CODE CHANGES RESOURCE COLLECTION: 2009 IBC[®]

APPROVED CODE CHANGES RESULTING IN THE 2009 IBC[®]

Publication Date: March 2009

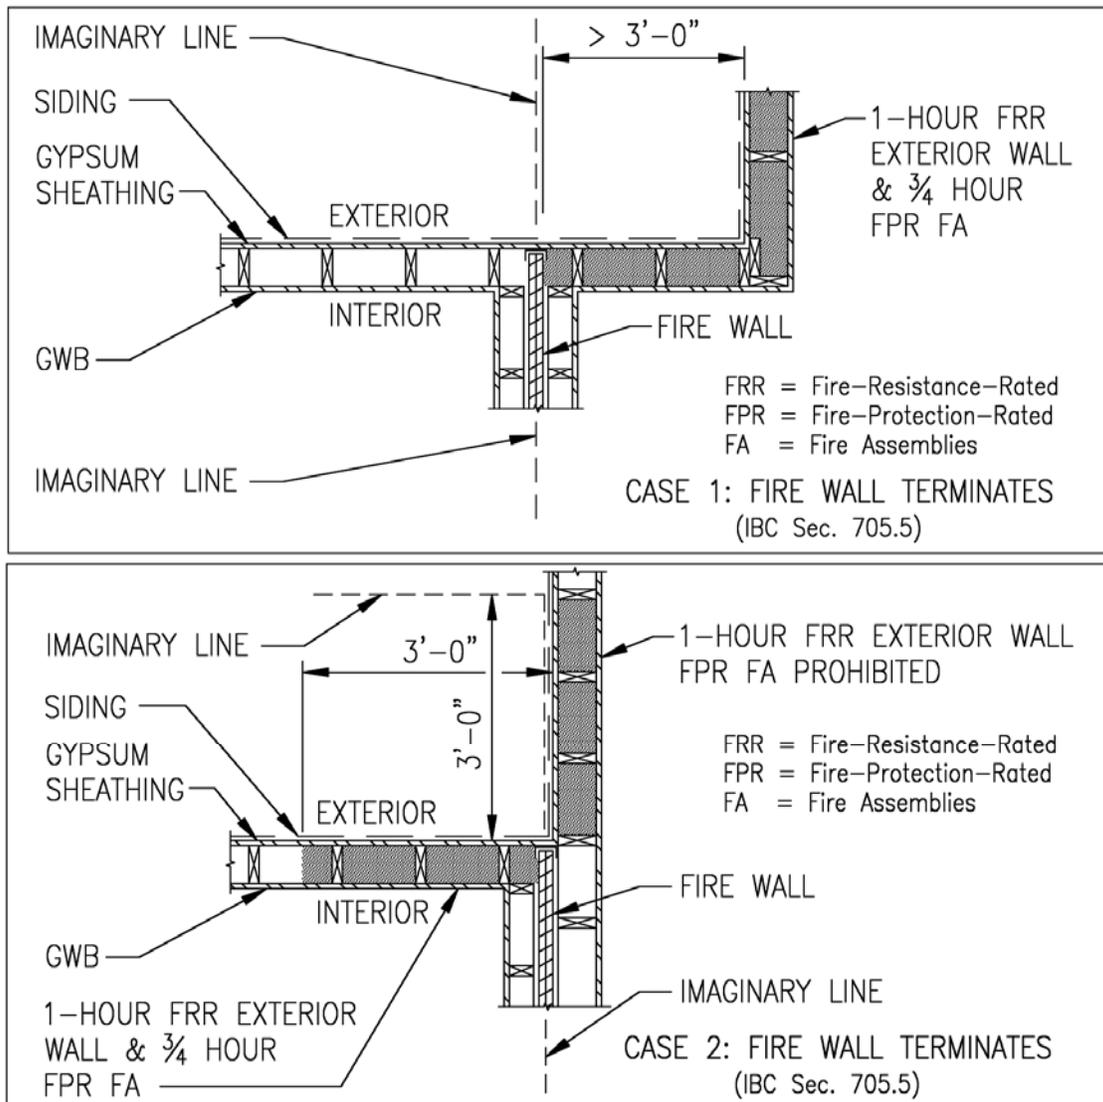
Determining the fire-resistance rating and opening protection of the exterior wall “where opening protection is required” is also problematic. The protection ought to be based on the proximity of the exterior wall on one side of the fire wall to the exterior wall on the other side of the fire wall, which is moot when the exterior angle formed by the exterior walls is equal or greater than 180 degrees.

The accompanying diagrams illustrate applications of the proposed changes requiring fire-resistance-rated construction at the exterior wall on either side of the fire wall but also permitting openings at certain fire separation distances from the imaginary line provided they are 3/4-hour fire-protection-rated assemblies. Once permitted, the allowable percentage of fire-protection-rated would be small at small fire separation distances, increasing at larger distances until unprotected openings are permitted.

FIGURE 1611.1 IPC-1106.1
100-YEAR, 1-HOUR RAINFALL (INCHES) EASTERN UNITED STATES

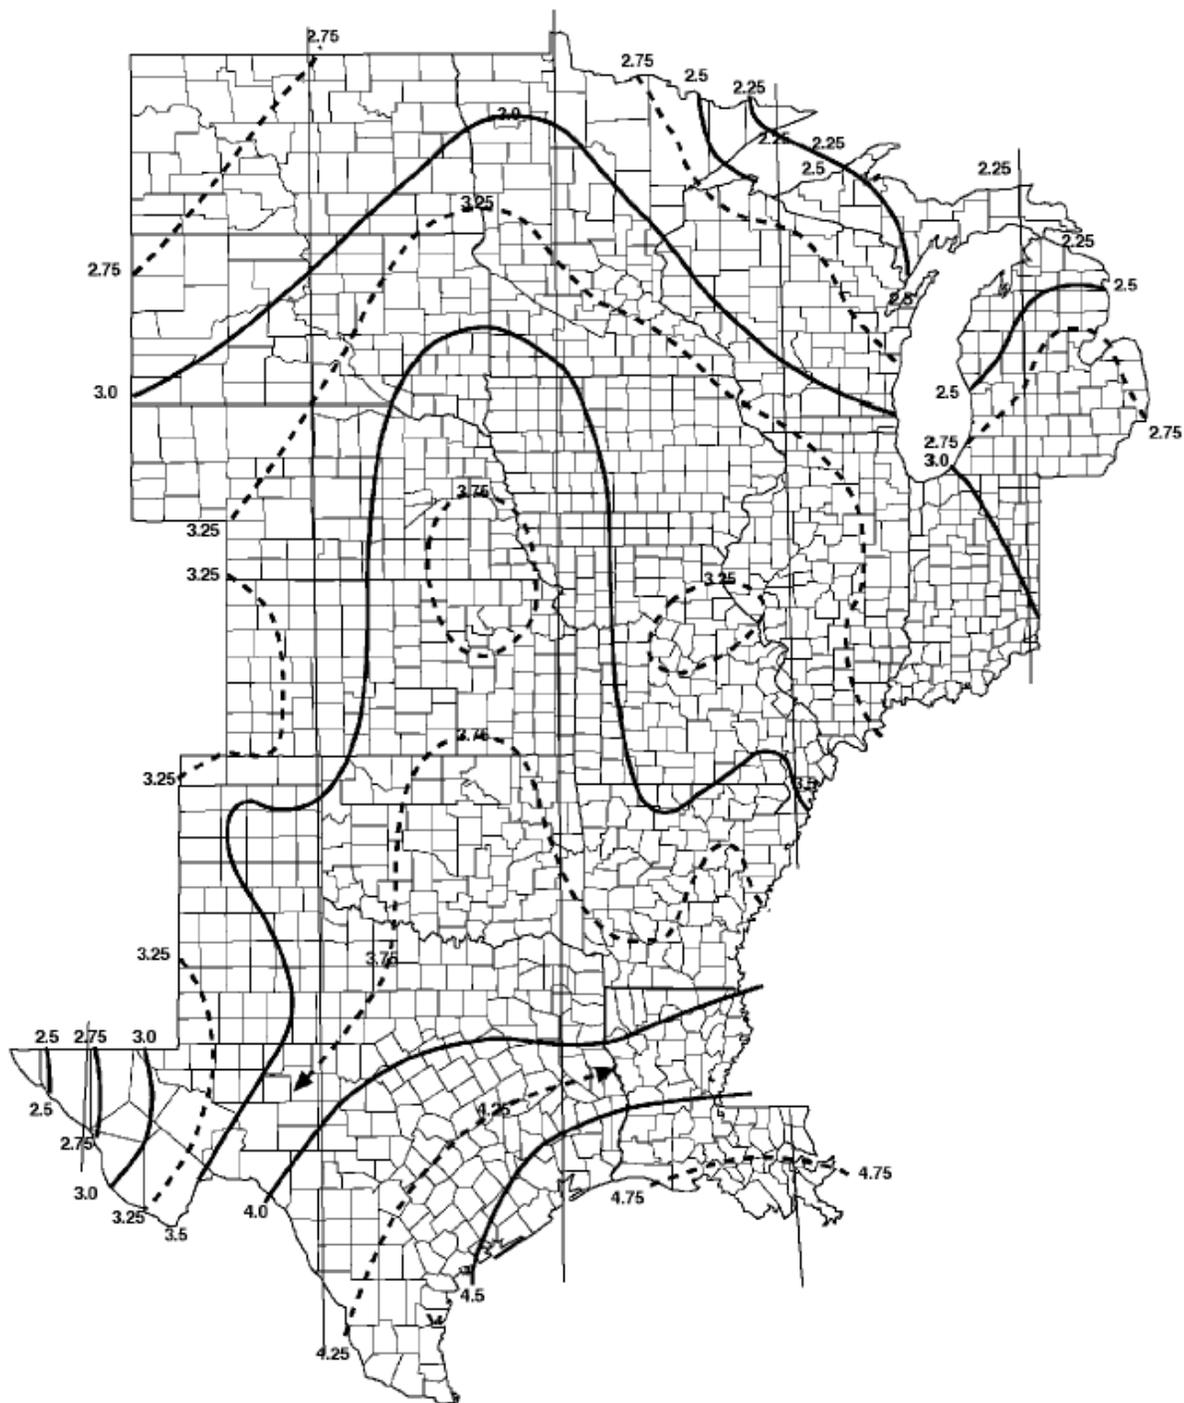
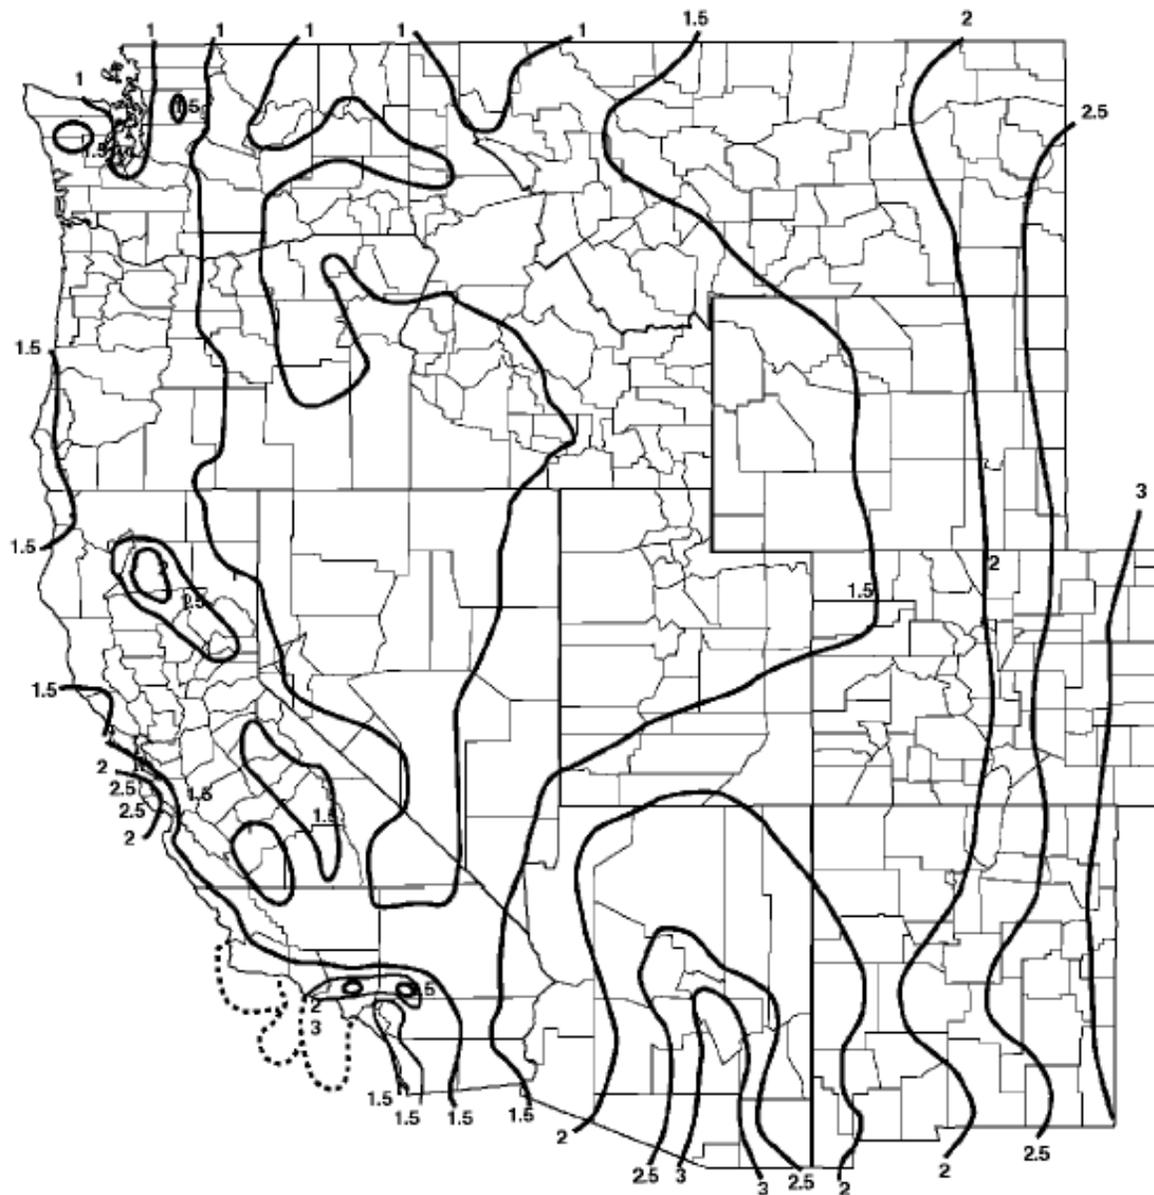
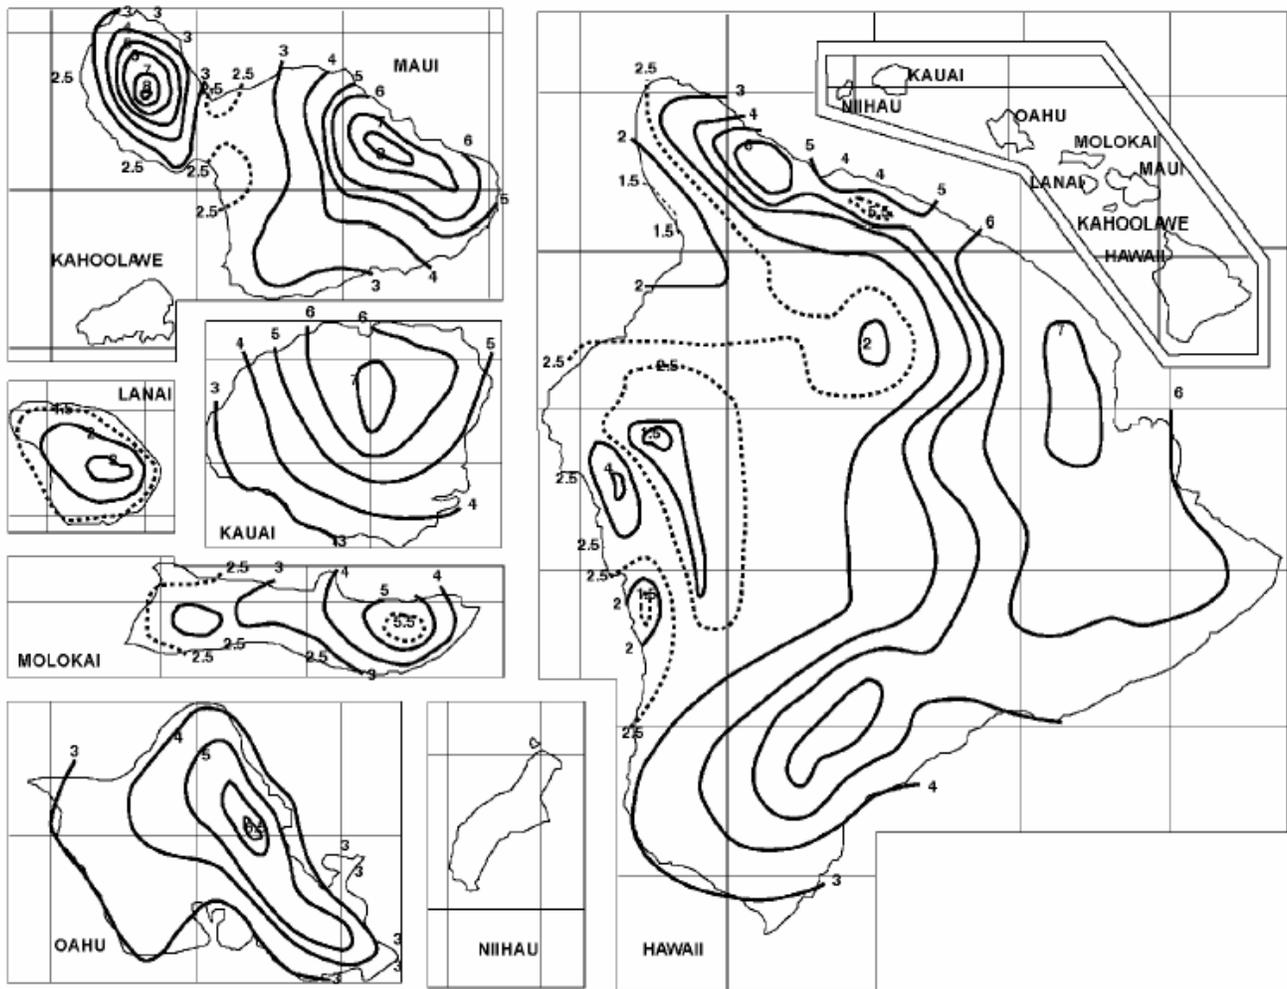
Insert all of IPC Figure 1106.1 and renumber as shown

This code change proposal copies the pertinent roof drainage requirements contained in International Plumbing Code (IPC) Chapter 11 into Chapter 15 of the International Building Code (IBC) to make it more readily available to designers who are responsible for the structural load carrying capacity of roofs. This code change also adds verbiage from the IPC to IBC Section 1611.1 for determining the design rainfall, and copies the rainfall intensity map found in the IPC (Figure 1106.1). Currently this information is only available in the International Plumbing Code.

1611.1 Design rain loads. Each portion of a roof shall be designed to sustain the load of rainwater that will accumulate on it if the primary drainage system for that portion is blocked plus the uniform load caused by water that rises above the inlet of the secondary drainage system at its design flow. The design rainfall shall be based on the 100-year hourly rainfall rate indicated in Figure 1611.1 or on other rainfall rates determined from approved local weather data.

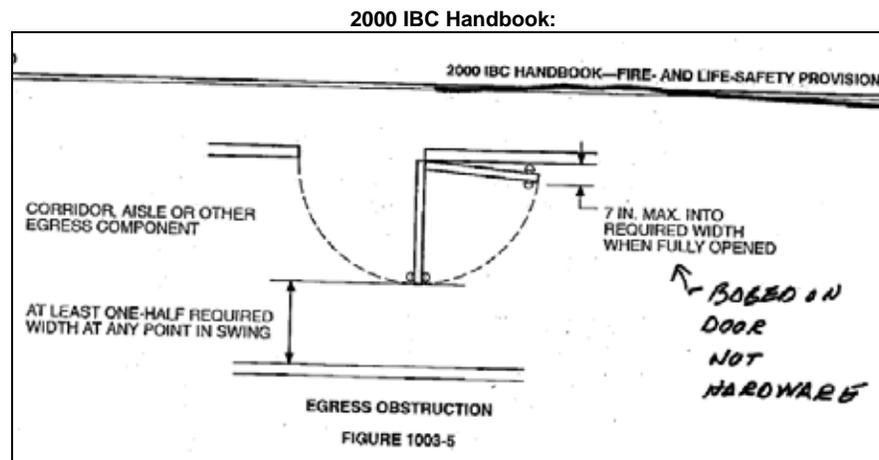
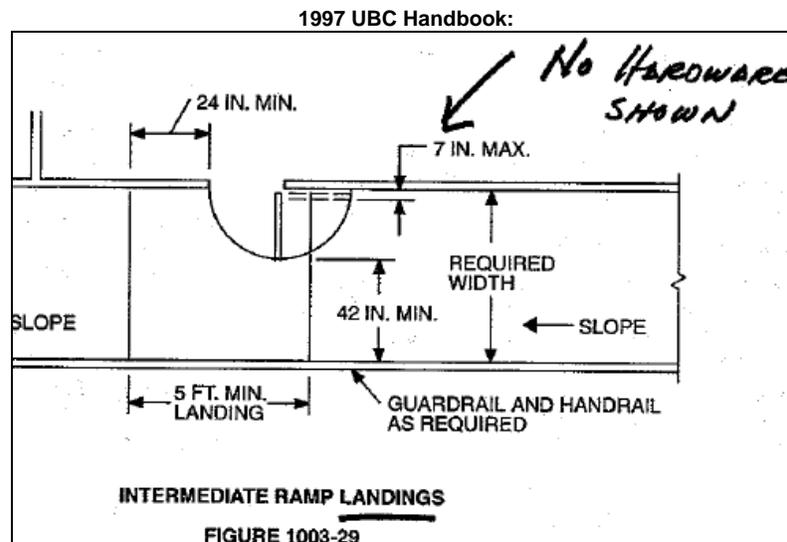
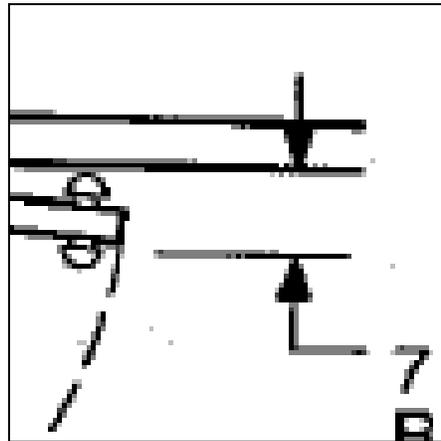
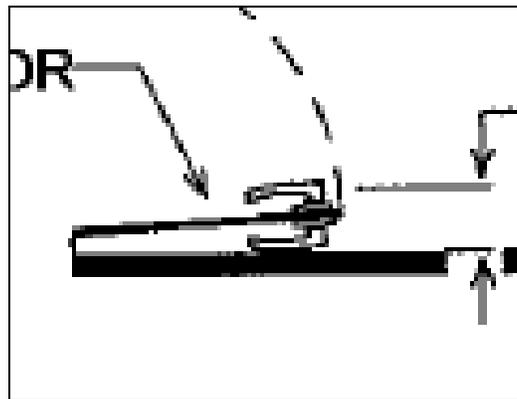
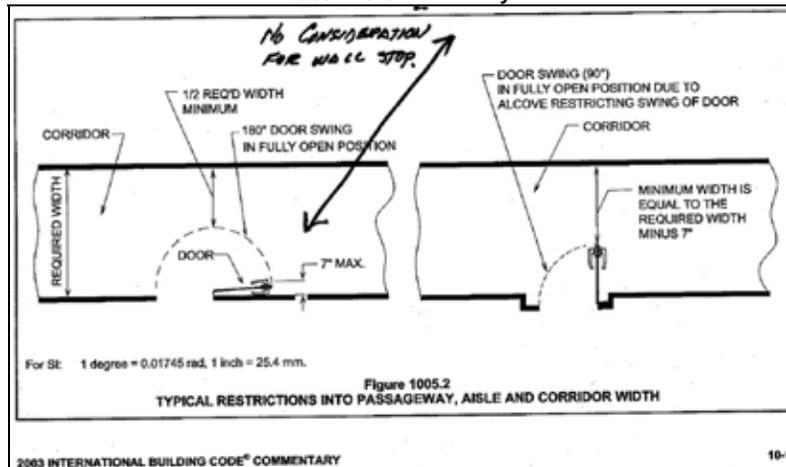
The best illustration of just how confusing the current text is, and the best justification for this needed clarification, are the ICC Commentaries. The 7" door encroachment requirement is based upon legacy code provisions and has survived intact. In the *1997 UBC Handbook*, figure 1003-29 provides a detail with a dimension indicating a maximum of 7" door encroachment, but the figure shows no hardware and the dimension line leads to the edge of the door surface. Fast-forward to the *2000 IBC Handbook Fire and Life-safety Provisions* and to figure 1003-5. In this detail, hardware has been added to the illustration but the 7" dimension line has moved to some vague point between the door slab and the doorknob. In the *2003 IBC Commentary* Figure 1005.2, the detail has been modified to show accessible hardware instead of a doorknob, but the dimension line again leads to some vague spot on the door latch.

Despite the fact that the technical provision for door encroachment has not changed since the legacy codes, ICC artists have arbitrarily changed the details in the commentaries. The clarification provided by this proposal is necessary to clean up the ambiguity and resolve the issue in order to facilitate consistent code interpretations. The proposal is not a change in the requirement, merely a clarification made necessary by the confusion created by the ICC commentaries.

The following details are taken from the above referenced ICC and ICBO publications.

Figure 1. Bumper Load Application

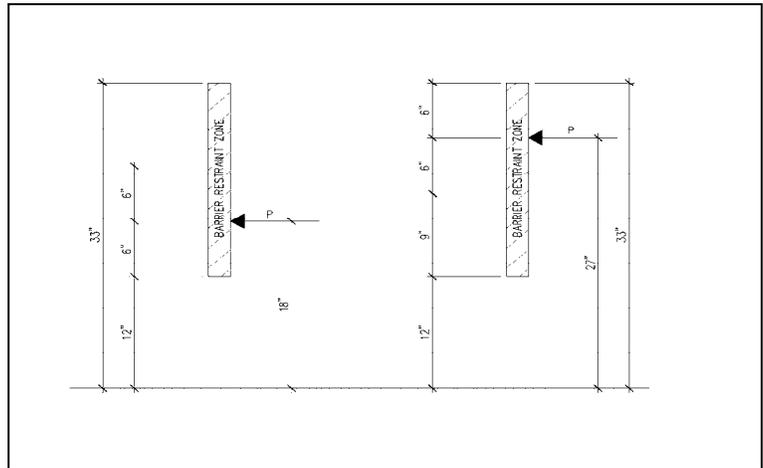
In addition to revising the bumper height used in designing barrier restraints for parking structures, the applied load may also need to be revised. Light trucks and SUV's are heavier than the typical automobile. The empty weight of a Lincoln Navigator, a large sport utility vehicle (SUV), is approximately 7,000 pounds. Some large pick-up trucks have gross (loaded) weights of up to 10,000 pounds.

Also, the speed at point of impact may have to be reconsidered. At least one of the failure incidents reported a speed of 10 to 14 mph compared to a speed of 5 mph used to determine the current load requirement.

Finally, the design methodology may have to be revised. The key to vehicle impact restraint design is to absorb and dissipate the kinetic energy created by the moving vehicle impacting the barrier. The kinetic energy is created by a combination of the vehicle speed or velocity and the vehicle weight where $KE=1/2mv^2$.

**FIGURE 408.5.3(1)
MULTILEVEL RESIDENTIAL HOUSING WITHOUT
VERTICAL OPENING ENCLOSURE**

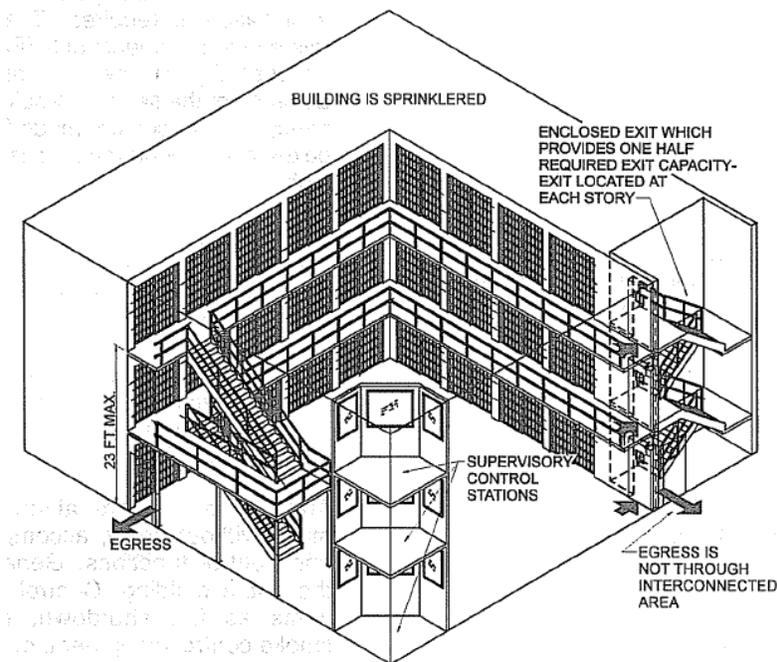
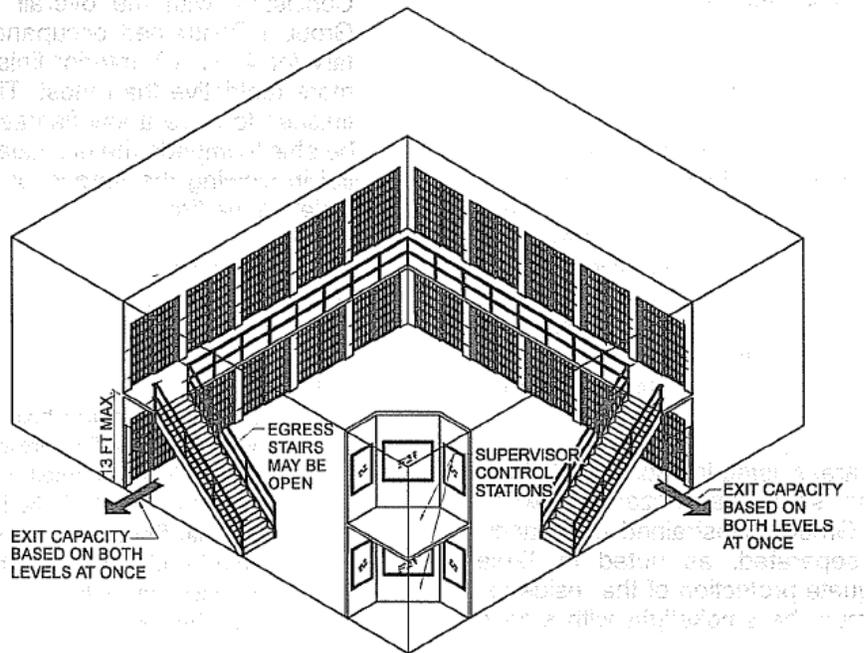
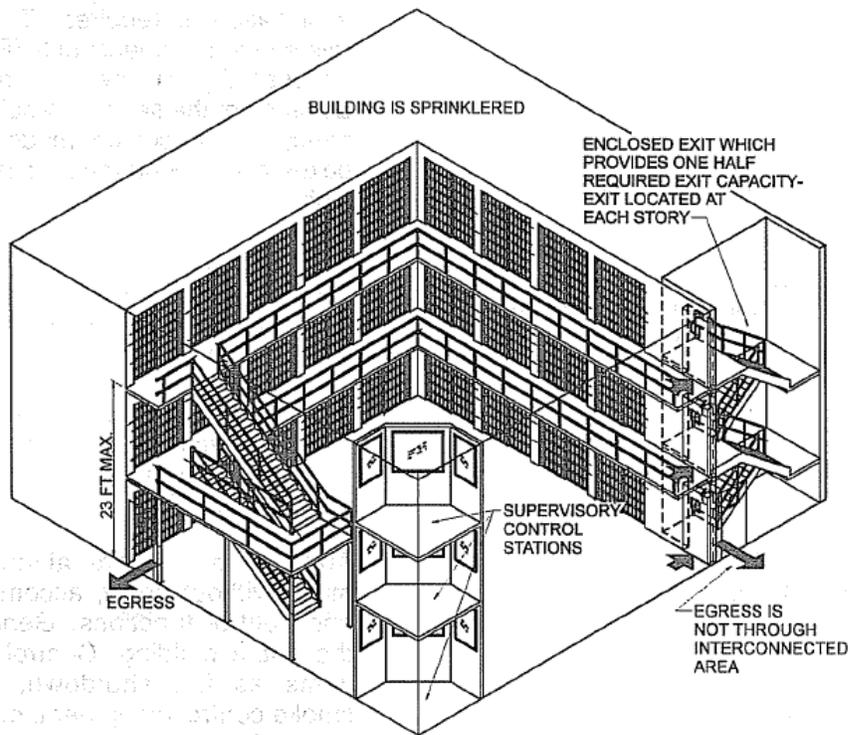
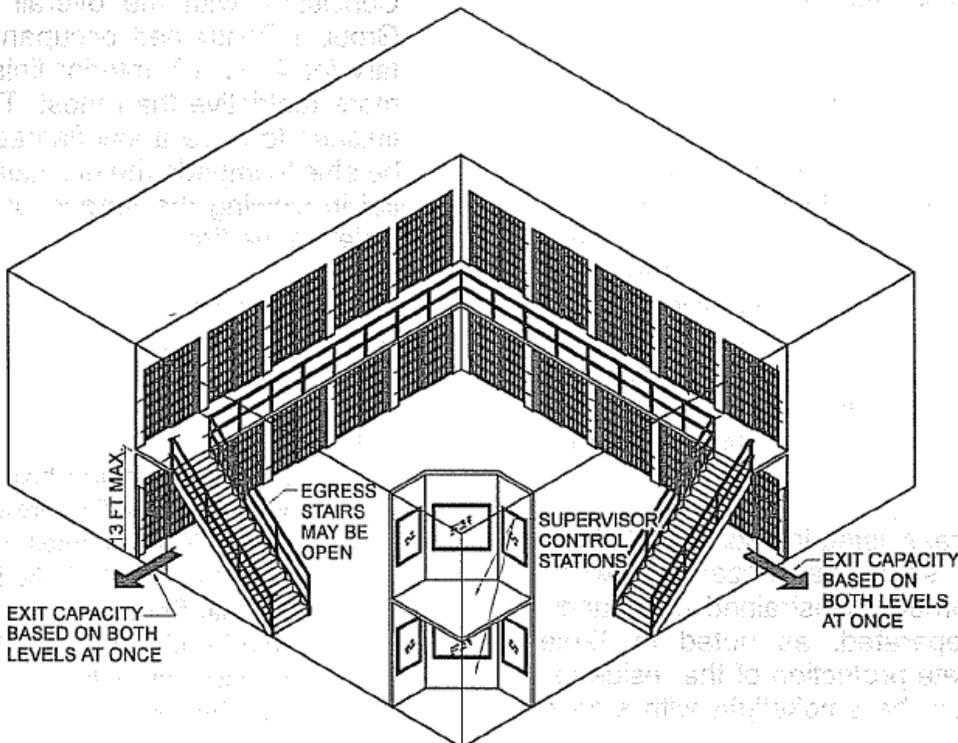
Reason: This change is intended to clarify the exiting from floor levels within the residential housing units. Without this change the “floor levels” get treated as stories and additional exits are required. Currently a residential housing unit with two floor levels and a very small occupant load can be required to have three exits which in a detention facility is problematic. This change would then allow the two level units to have just two exits with no direct egress from the upper floor level as long as common path and travel distances are met. The figures below illustrate the proposal and should be included in the commentary.

Exception: When the height difference between the highest and lowest finished floor levels does not exceed 13 feet (7010 mm) egress may traverse another floor level in the interconnected area.
